IN THE MATTER of a submission in respect of the **PROPOSED WAIKATO DISTRICT PLAN** by **AMBURY PROPERTIES LIMITED** pursuant to Clause 6 of Schedule 1 of the Act seeking the rezoning of land at Ohinewai

SUPPLEMENTARY STATEMENT OF CAMERON BESWICK INDER

Relocating the steel guard rail

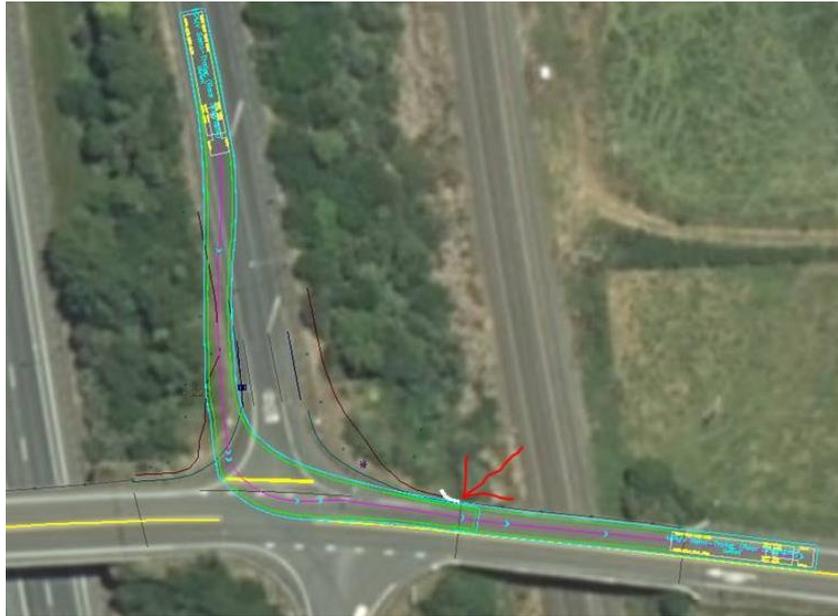
12. I specifically use the word "perception" here because, from my observations, it is not absolutely necessary for large trucks to cross the centreline to successfully complete the turn. Some large trucks do not cross the centreline, and some do while leaving a large gap to the bridge abutment. Those that do cross the centreline appear to mostly because it is convenient and they can do so without causing any problem. Those drivers wait for opposing traffic to clear then make the turn. From my observations, the trailer of large trucks that do not cross the centre line, tracks close to the rail overbridge abutment parapet. The photo that I took below on site illustrates the gap this driver afforded himself while the front wheels went slightly over the centreline, and the body path crossed approximately 0.5m over the line.

14. The first alternative measure involves relocating the steel guard rail that currently connects to the northeast rail bridge abutment parapet, to instead connect to the wingwall in a similar way to the guardrail on the opposite side (circled in red below). The red dashed line illustrates the approximate realignment of the guard rail, to illustrate my point. This increases the clearance width up to the bridge. It is feasible from a construction point of view to reestablish the guardrail further back, and from the structural engineers advice, for the connecting to the wingwall instead of the parapet.
15. This is likely to assist to relieve the perception to truck drivers that the bridge approach is too narrow without crossing the centre line.
